UNITED STATES NUCLEAR REGULATORY COMMISSION WASHINGTON, D.C. 20666

FACILITY: Comanche Peak Steam Electric Station, Units 1 and 2 (CPSES)

SUBJECT: SUMMARY OF MEETING ON CPSES THERMO-LAG TESTING PROGRAM

THERMAL ANALYSIS FOR SUPPORTS

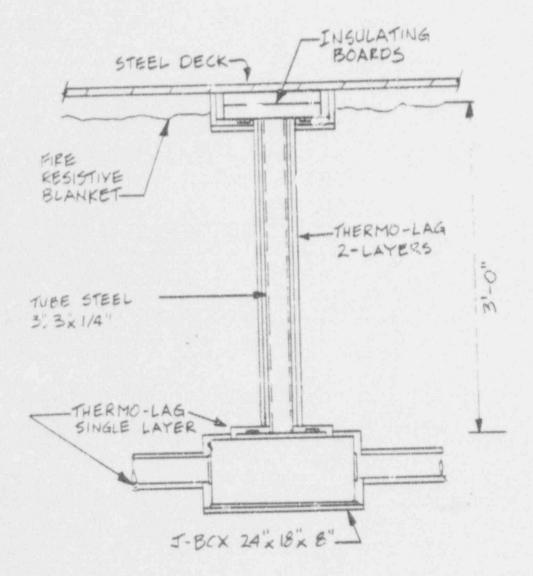
Determine heat loss (change in tenporature) of the 24"x18"x8" junction box due to thermal conduction into the support steel.

Assume junction box temperature to be 483 degrees F for the entire hour for conservatism and simplification of the model. This is based on the maximum average thermocouple readings during the actual fire test on the junction box.

Assume the support for the junction box is the worst case since the junction box exibited the highest steel temperatures in the crea of the supports thus creating the greates, temperature differential.

Using these very conservative assumptions there was a 15 degree F maximum reduction in temperature on the junction box steel for the one hour ASTM E-119 exposure due to the transfer of heat through the support.

THERMAL ANALYSIS MODEL FOR CONDUIT TEST ASSEMBLY

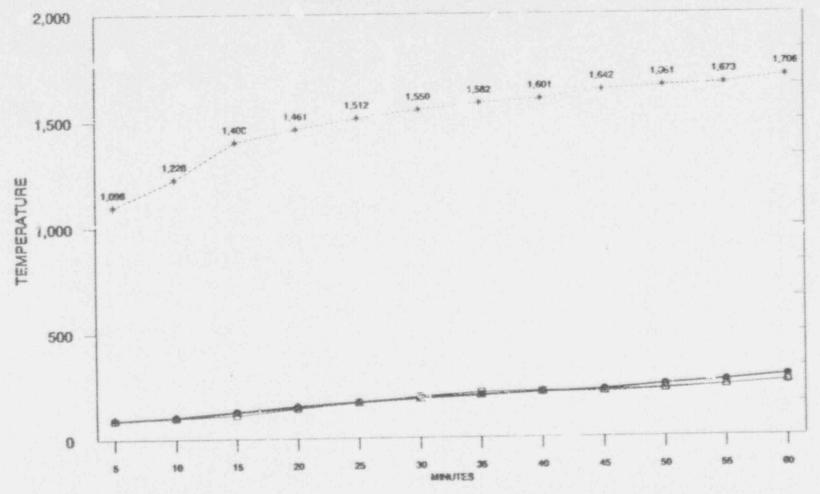
MPACT OF SUPPORTS ON TEST RESUL.S

THERMAL ANALYSIS HAS BEEN PERFORMED FOR THE CONDUIT ASSEMBLY TESTED WHICH DEMONSTRATES THAT THE SUPPORTS HAVE NEGLIGIBLE EFFECT IN CONDUCTING HEAT AWAY FROM THE TEST ENVELOPE.

SUBSEQUENT TESTS WILL MINIMIZE THE NUMBER OF SUPPORTS AND CLOSELY MODEL PLANT SUPPORT SPACING. SUPPORTS WILL BE PROTECTED WITH A SINGLE LAYER OF THERMO-LAG. THERMOCOUPLES WILL BE INSTALLED ON THE CONDUIT ASSEMBLY SUPPORT TO MEASURE TEMPERATURE DIFFERENTIAL FROM THE TEST ENVELOPE.

TIME - TEMPERATURE CURVES

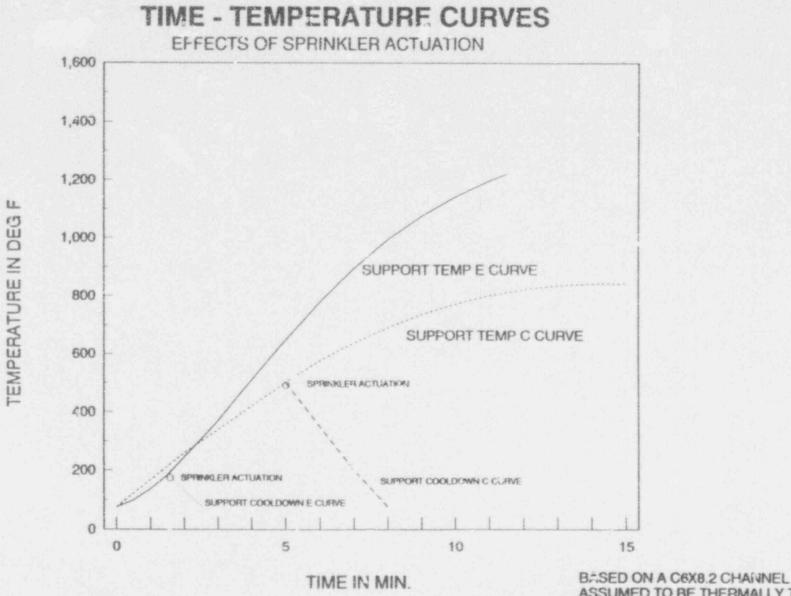
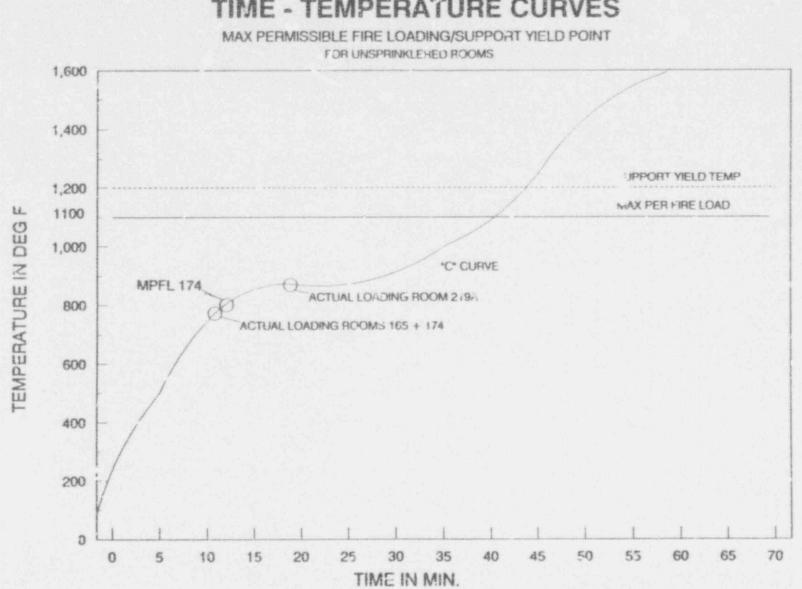
FOR AREAS WITH SPRINKLER PROTECTION, DEMONSTRATE SPRINKLERS WILL ACTUATE AND SUPPRESS THE FIRE BEFORE THE SUP-PORTS REACH THEIR YIELD "OINT. FOR AREAS WITHOUT SPRINKLER PROTECTICN, DEMONSTRATE LOW COMBUSTIBLE LOAD'N IG AND ADMINISTRATIVE CONTROLS ENSURE SUPPORT INTEGRITY WILL NOT BE CHAL-LENGED BY A DESIGN BASIS FIRE.

- 1. THE YIELD POINT OF THE SUPPORT IS 1200 DEGREES F, BASED ON THE DEAD WEIGHT STRESS ON THE SUPPORTS BEING 20% OF YIELD.
- 2. THE SPRINKLER RESPONSE TIME IS BASED ON A RESPONSE TIME INDEX (RTI) OF 285 WHICH WAS DETERMINED BY OVEN TESTING OF SPRINKLERS AT CPSES.
- 3. THE FIRE WILL BE LOCATED IN THE MIDDLE OF FOUR SPRINKLERS, POSITIONED 10 FT. ON CENTERS. THIS IS CONSERVATIVE BASED ON PLANT CONFIGURATIONS.

1. BASED ON THIS VERY CONSERVATIVE APPRCACH, SPRINKLERS WILL ACTUATE AND SUPPRESS THE FIRE, WELL BEFORE THE SUPPORTS REACH THEIR YIELD POINT.

C-CURVE FIRE:	SPRINKLER ACTUATION: 5 MINUTES SUPPORT YIELD WITHOUT SPRINKLERS: 42 MINUTES
E-CURVE FIRE:	SPRINKLER ACTUATION: 1.5 MINUTES SUPPORT YIELD WITHOUT SPRINKLERS: 11 MINUTES

2.IN ROOMS WITHOUT SPRINKLERS, EXIST-ING SUPPORT PROTECTION AND ADMIN-ISTRATIVE CONTROLS ENSURE THAT SUPPORTS WILL NOT FAIL DURING A FIRE.
